**TOWN OF MOUNTAIN VILLAGE  
REGULAR DESIGN REVIEW BOARD MEETING  
THURSDAY SEPTEMBER 5, 2019 10:00 AM  
2nd FLOOR CONFERENCE ROOM, MOUNTAIN VILLAGE TOWN HALL  
455 MOUNTAIN VILLAGE BLVD, MOUNTAIN VILLAGE, COLORADO  
AGENDA**

**TO:** Design Review Board  
**FROM:** Sam Starr, Planner  
**FOR:** Meeting of September 5, 2019  
**DATE:** August 27, 2019  
**RE:** Initial Architectural and Site Review for a new single-family home on Lot BC105, 114 Lawson Overlook

<b>JACK WESSON ARCHITECTS INC.</b> 110 SOUTH PINE STREET TELLURIDE, COLORADO 81435 TEL: 970.728.9755 FAX: 970.728.9724 jwesson@me.com www.jackwessonarchitects.com
PROJECT NAME: BC 105 MOUNTAIN VILLAGE, COLORADO 81435	SHEET DESCRIPTION: COVER SHEET
7-29-19 DRB PACKAGE 4-29-19 REVIT 3D	SHEET NUMBER: A-000

PROJECT NAME: BC 105 MOUNTAIN VILLAGE  
PROJECT NUMBER: A101

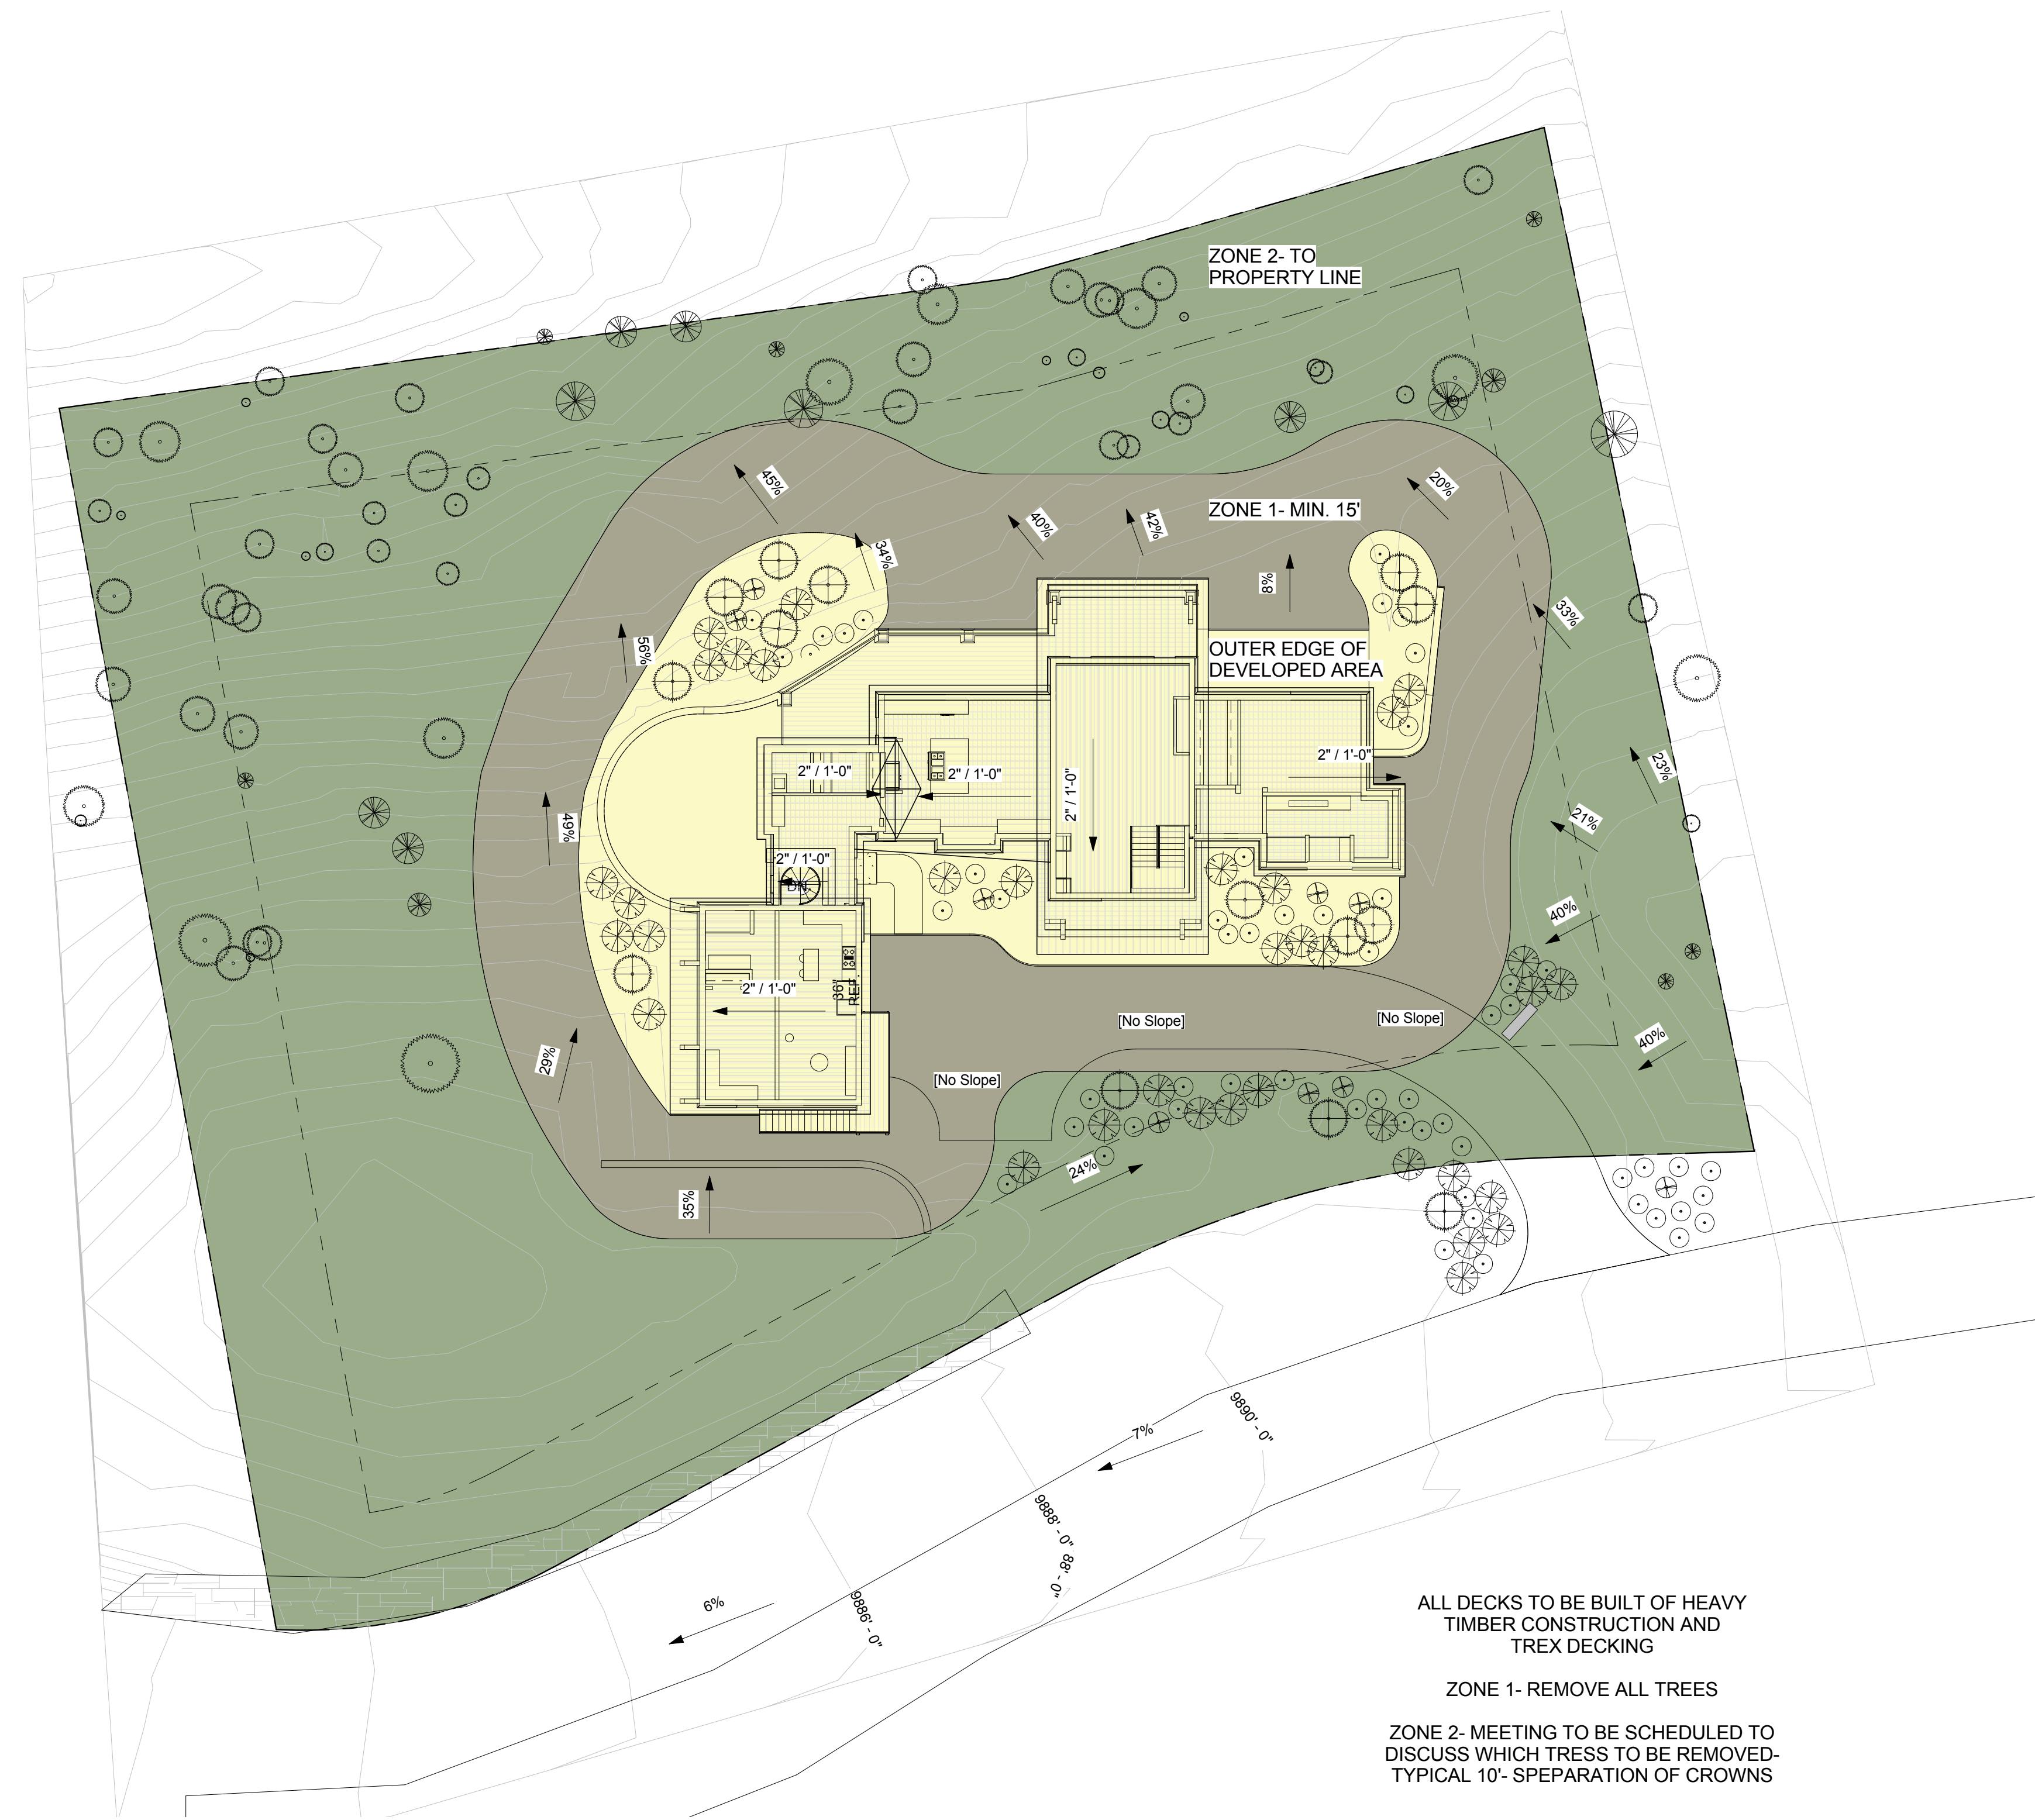
All construction staging is within the lot boundaries. However, the construction staging plan does show construction parking and disturbance in the General Easements. Staff finds this disturbance is minimal and will not adversely affect the surrounding properties. The configuration is necessary given the size and slope constraints of the site. The current plan as shown will need to be revised to include perimeter fencing for the entire lot, and not just silt fencing on portions of the northern side. Staff has included a condition in the recommendation section to address this.

SHEET NUMBER:  
**A102**

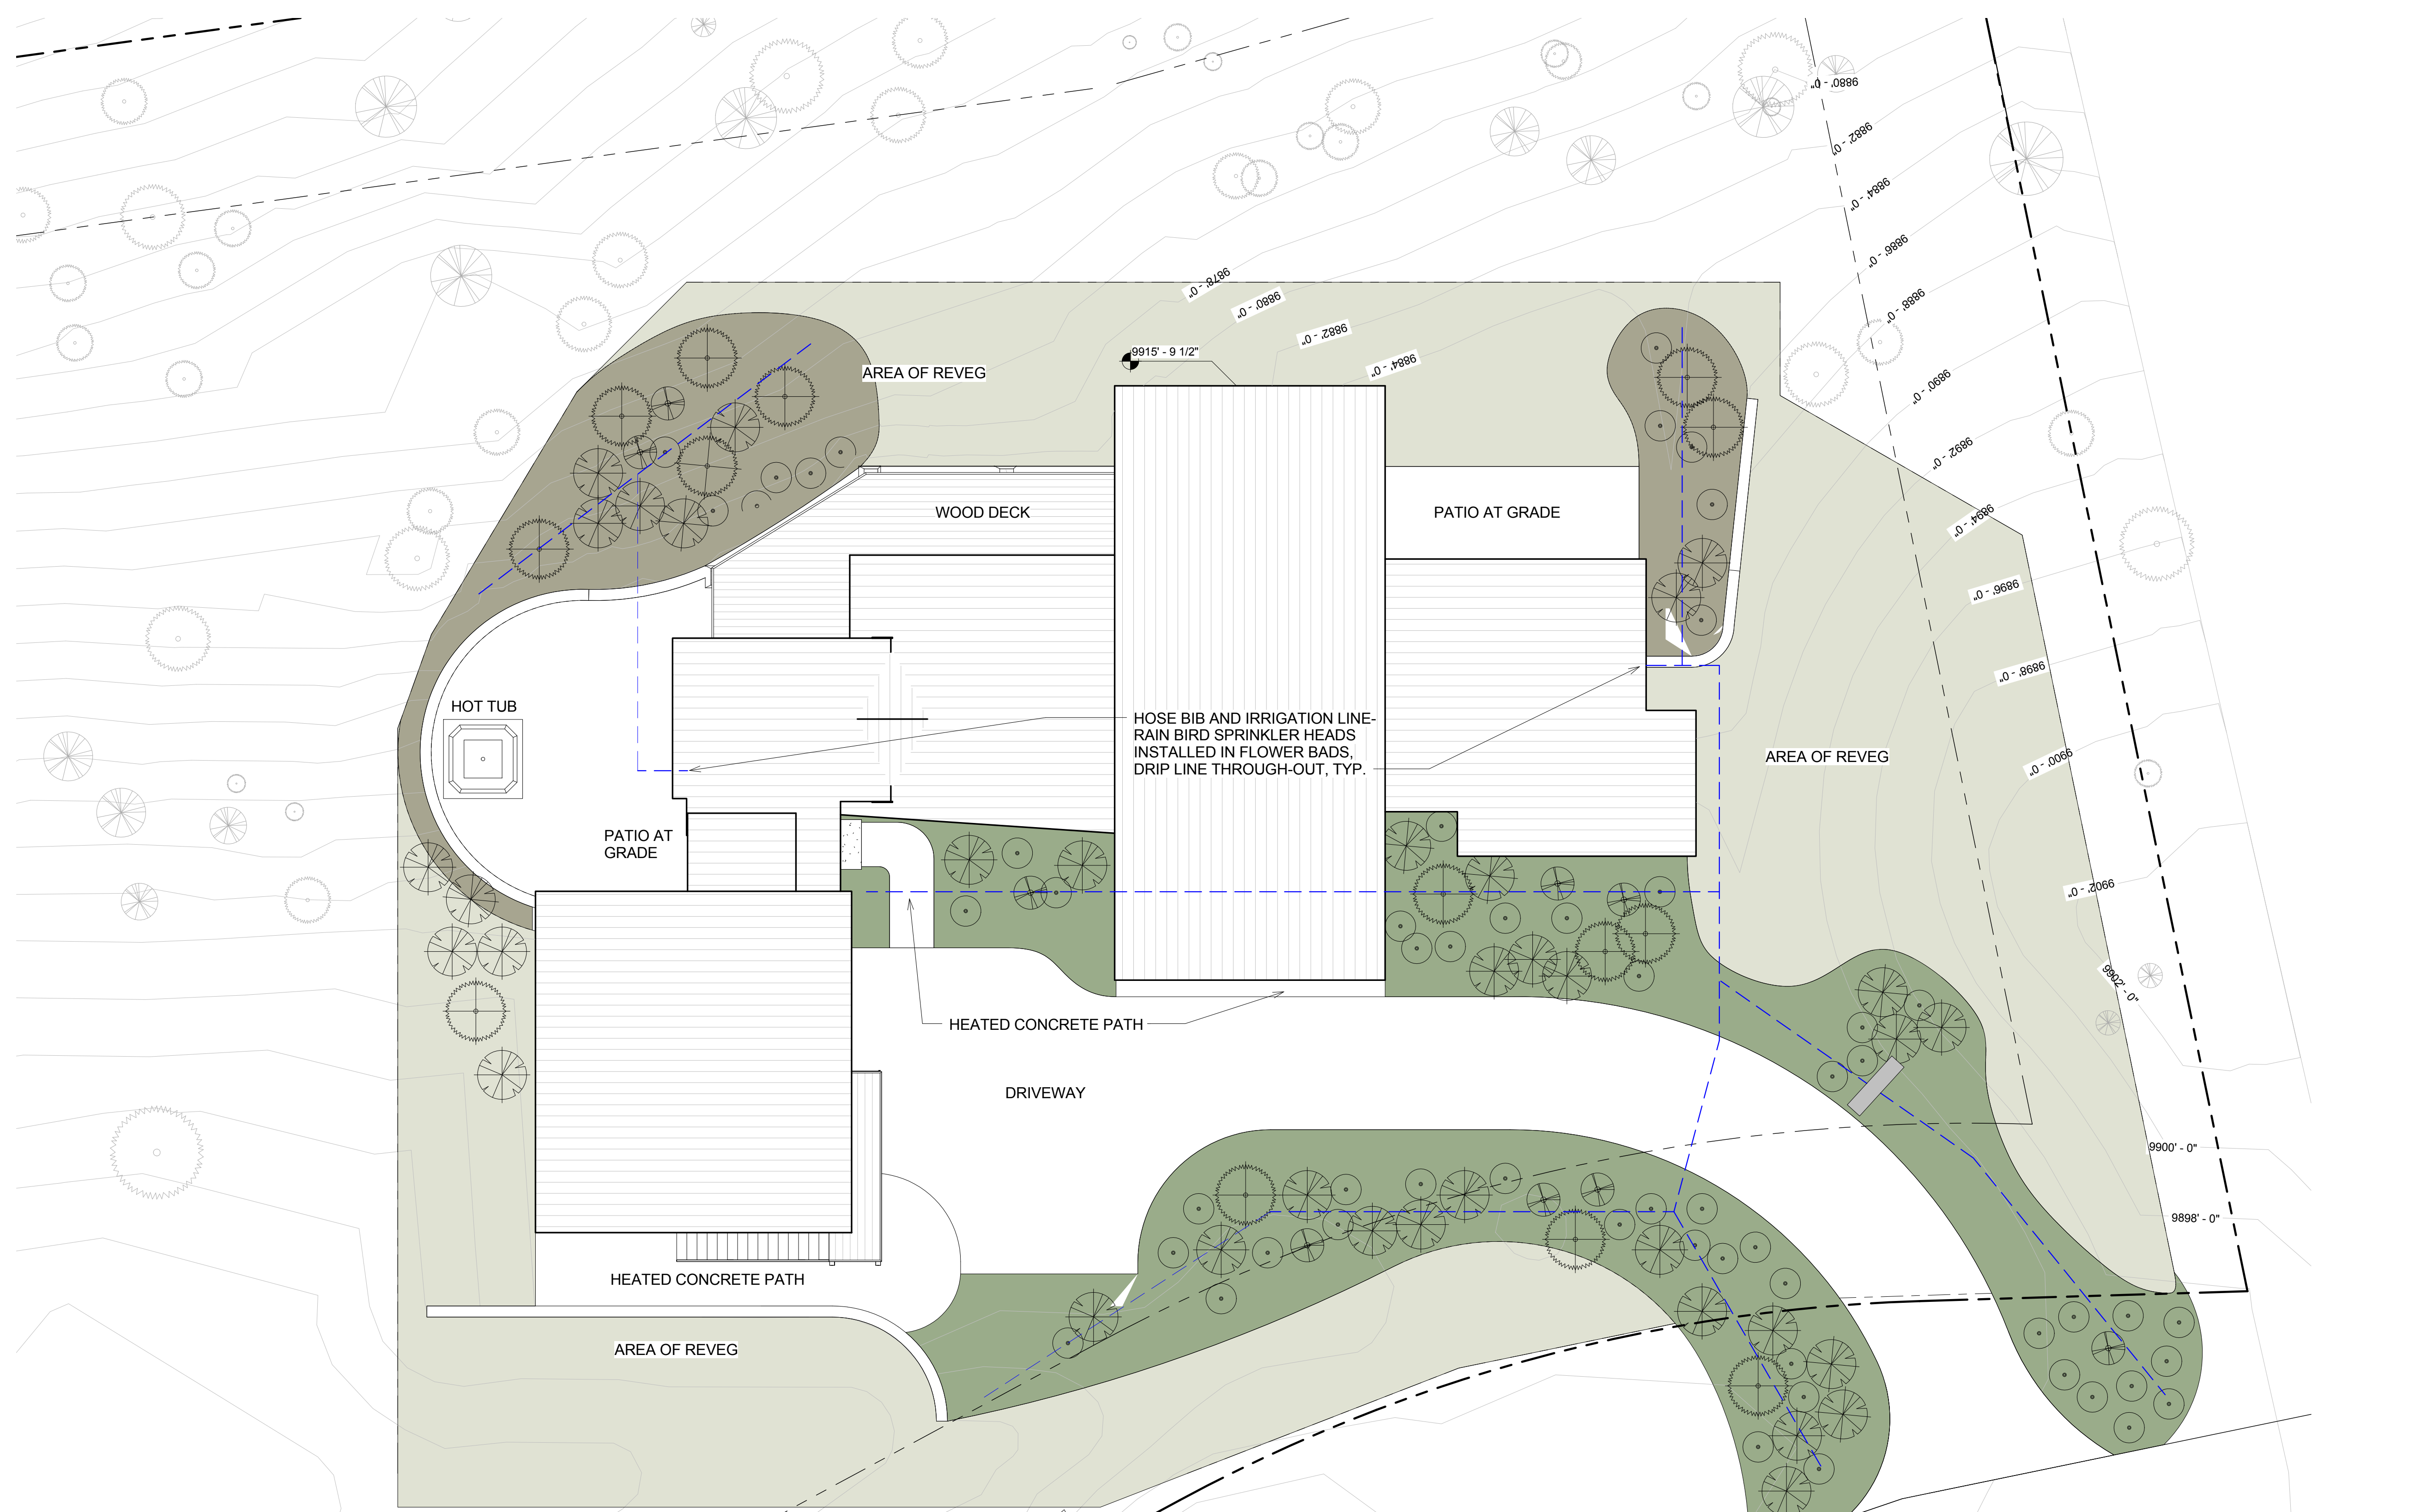
The applicant has provided a preliminary landscape plan. Staff recommends that the applicant remove all coniferous species from zone one. All plantings will need to be in compliance with Table 5-4 of the CDC:

- 4. Applicant shall revise his landscaping plan prior to Final Review, to indicate that no coniferous species will be planted in zone one of the wildfire mitigation zones.*
